Bridgepoint Project comments

From: Susan Nassar [mailto:susannassar@energistics.com]
Sent: Tuesday, December 8, 2020 6:24 PM
To: Town Council <mayorandcouncil@townofchapelhill.org>
Subject: Please include my Bridgepoint public comments letter in the Dec 9 Council meeting packet

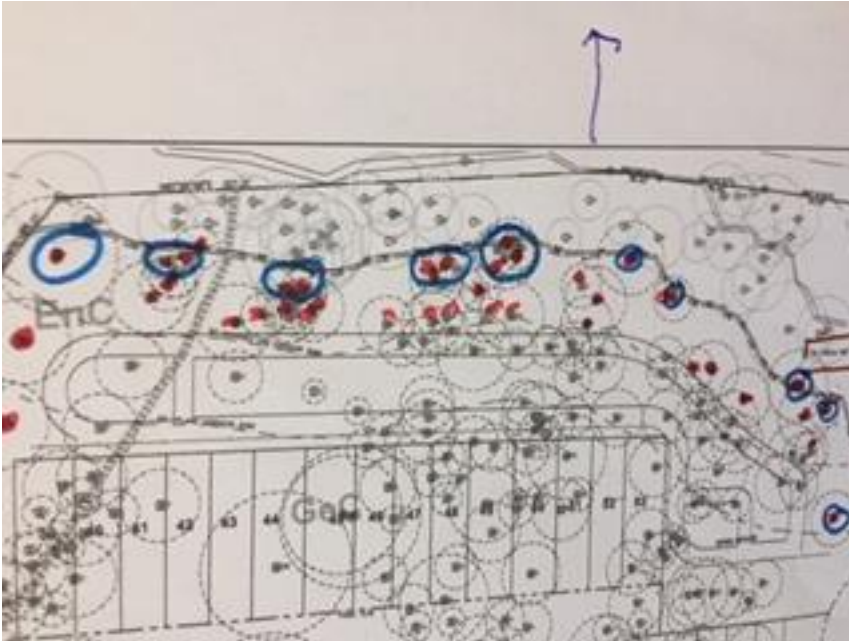
Please note the following diagram which is from page 8 of Bridgepoint's site plan. There is a zone of protection where nothing is disturbed as Mr Chupp stated – the first 50 feet near the stream. However the next 50 feet as you move toward the pond had every tree removed (area of the arrows) How is this disturbing only 22%? I apologize that the image is not clearer but you can go to the site plan on page 8 see in detail every tree removed

I suggest that more trees could be saved , especially the “high Value trees” mentioned in Chapel Hill Ordinance about water buffers. These I have circled in blue and the red dots are maybes.

I would like the developer to reconsider the pond area. Make it smaller (maybe even the pond smaller) to do less destruction. When possible the natural areas in this town need to be preserved for future generations, even is on the small aside. I know not every tree can be preserved but more than what is here in this plan.

While this is good news it still does not address the issue of why so many trees are being cut in zone between pond and stream buffer no development on the Bridgepoint side of the stream . Again I think more trees can be saved as seen in the above drawing . The two underlines sentences seem to be opposites. The buffer between the bottom of the pond will have no grading or clearing and then later 100 feet outside of the stream side buffer will be stabilized with grasses and plantings ? I am at least hopeful that more scrutiny will be done on the area and I thank Eric for emailing me. Hopefully they are truly reconsidering the area.

The buffer between the bottom of our proposed water quality pond is more than 50' off the stream bank and therefore there will be no clearing or grading there at all. Then there is a 150 foot stream buffer on your side of the creek (the north side). Partly on our property, partly on the Town's property, and partly on the Vineyard Square property. No clearing will take place anywhere there. This is a huge wooded area. Then on our side of the creek for the next 100 feet outside the 50 foot streamside buffer it will all be stabilized with grasses and plantings. There will be no impervious surface. We will continue to try to shrink the pond size as we start to work on the actual construction drawings so things may get even better. Hope you are feeling better.
